STATE OF MAINE
DEPARTMENT OF TRANSPORTATION
16 STATE HOUSE STATION
AUGUSTA, MAINE 04333-0016

June 3, 2025
Subject: Woodland Fish Passage
System
WIN: PH20250514WFP
Location: **Baileyville**
Amendment No. 2

PROJECT:	16667
DRAWN BY:	C. HAGLER
DESIGNER:	A. MENGERT
APPROVED BY:	M. GRAESER
SHEET:	2 OF 240
DRAWING:	G-002

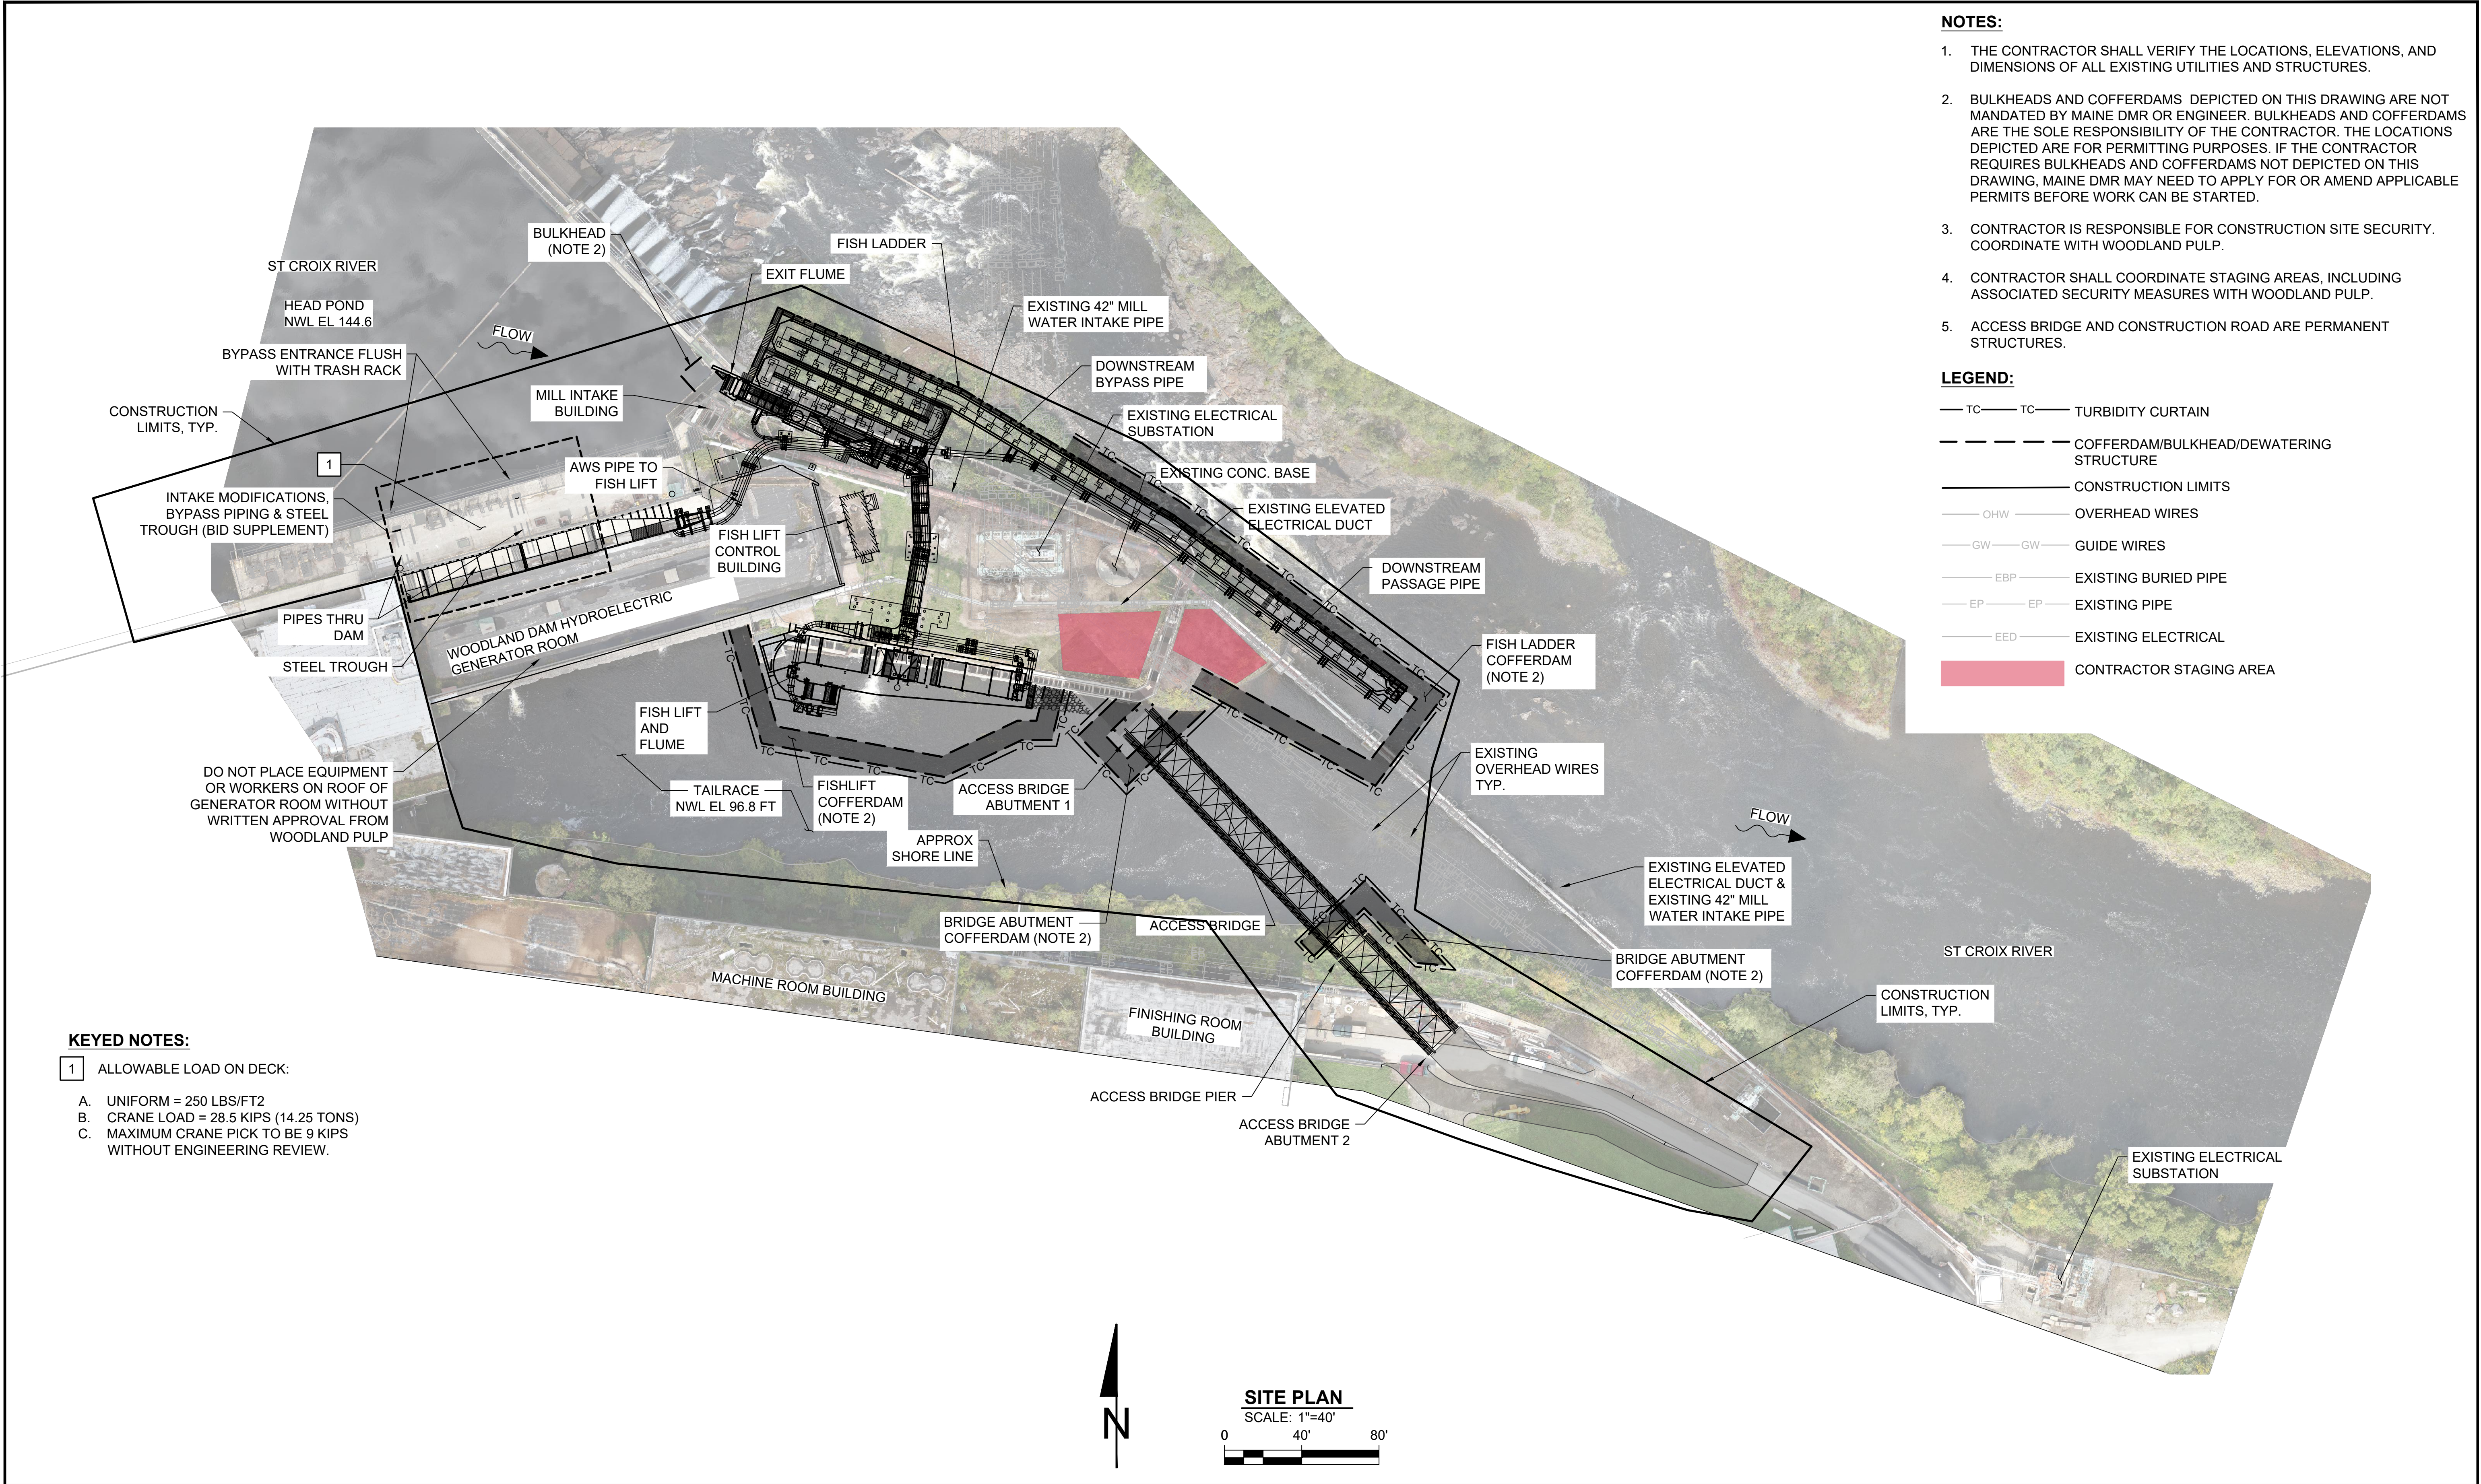
The following Drawing Sheets and Specification sections of Exhibits B and C were revised to denote "Bid Supplement" work items associated with Section 2, thereby superseding or removing all instances of "Not in Contract" or "(NIC)" previously depicted. Refer to the updated Notice to Contractors for additional information. Changes have not been clouded, redlined, or otherwise highlighted where applicable due to the nontechnical nature of the updates; this list therefore informs Bidders where to find “Bid Supplement” revisions and minor corrections as noted.

Drawing No.	Title	Exhibit
G-002	Drawing List	B-1
G-004	Abbreviations & Legend	B-1
G-120	Construction Limits & Staging Areas	B-1
G-130	Erosion Control & Dewatering Plan	B-1
D-100	Demolition Plan	B-1
D-103	Concrete Removal at Intake Dam	B-1
C-010	Overall Site Plan - General	B-2
C-011	Structure Control Plan	B-2
C-160	Downstream Bypass General Arrangement Plan	B-2
C-161	Downstream Bypass Section	B-2
C-162	Downstream Eel Bypass Sections and Details	B-2
C-163	Eel Package Backwash System	B-2
C-307	Fish Bypass 3 Profile	B-2
S-003	General Overview	B-3
S-160	Downstream Fish Bypass Plan	B-3
S-161	Downstream Fish Bypass Section	B-3
S-162	Bypass Trough Section	B-3
S-163	Bypass Trough Sections & Details	B-3
S-164	Bypass Trough Plans & Details	B-3
S-165	Downstream Fish Passage Section	B-3
M-001	General Mechanical Notes	B-4
M-002	General Mechanical Layout	B-4
M-160	Downstream Bypass Slide Gate (DSG-14 & DSG-15)	B-4
